Project No. 4678-052 – New York
Crescent Hydroelectric Project

Project No. 4679-049 – New York
Vischer Ferry Hydroelectric Project

Reference: Comments on Draft License Application

Comments on the Draft License Applications

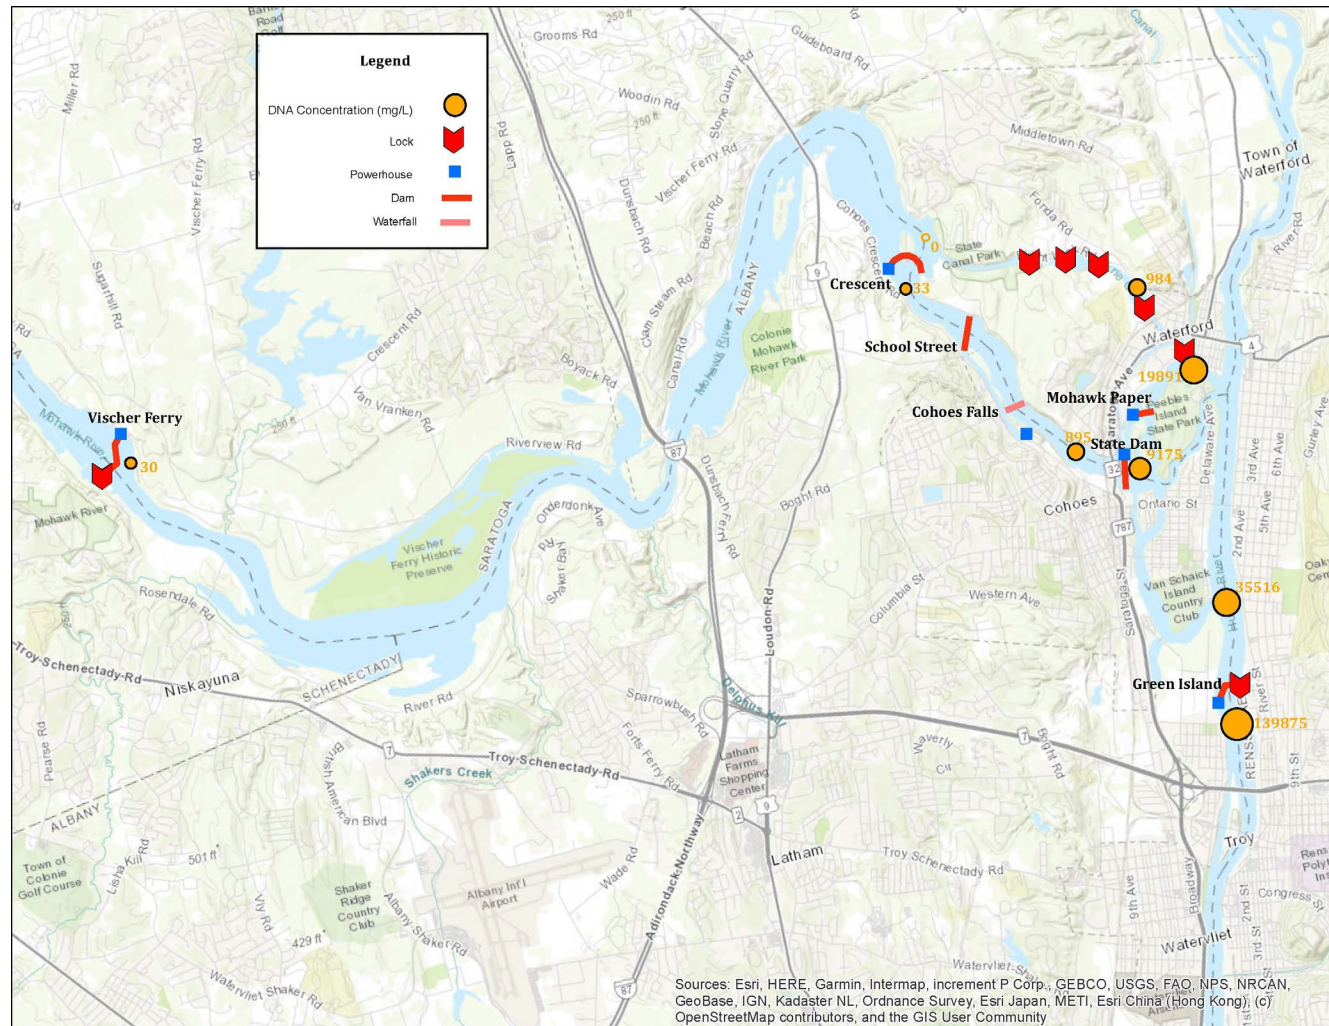
In addition to the effort conducted by the Applicant in 2021, the U.S. Geological Survey conducted an environmental DNA (eDNA) study in segments of the Hudson River, Mohawk River, and New York State Barge Canal to identify the presence of American Eel in the study area.¹ The study found that American Eel eDNA was detected below both the Crescent and the

Vischer Ferry Project dams (Enclosure A). The detection of eel eDNA was strongest below the first barrier at the Green Island Project (Project No. 13) dam, as would be expected. Above Green Island, detections dropped by an order of magnitude in the Hudson River and confluence with the Mohawk River. Detections subsequently declined within the Waterford Flight of the New York State Barge Canal and in the Mohawk River upstream of the confluence. At the time of the study, none of the barriers in the study area provided upstream eel passage facilities; therefore, it is not unexpected to see strong declines in American Eel detection above subsequent barriers in a river system.

The positive American Eel eDNA detections at the Projects confirm our understanding that a small population of eels exists in the vicinity of the Projects. The Projects obstruct the upstream migration of American Eel, once historically abundant upstream of the Projects, and can cause mortality and injury during downstream migration. The Service expects an increased occurrence of American Eel in the vicinity of the Projects during the new license terms. The Green Island Project is required to provide upstream passage and downstream protection for American Eel and has begun an interim upstream passage effort for 2021 until the final facilities are constructed.² The New York State Dam Project (Project No. 10457), the first barrier on the Mohawk River where regular detections of eel eDNA occurred in 2021, will be relicensing during the first quarter of the new license terms. The Service will evaluate potential upstream and downstream fish passage measures, including measures for American Eel, at the Projects during the development of our fishway prescription during this relicensing.
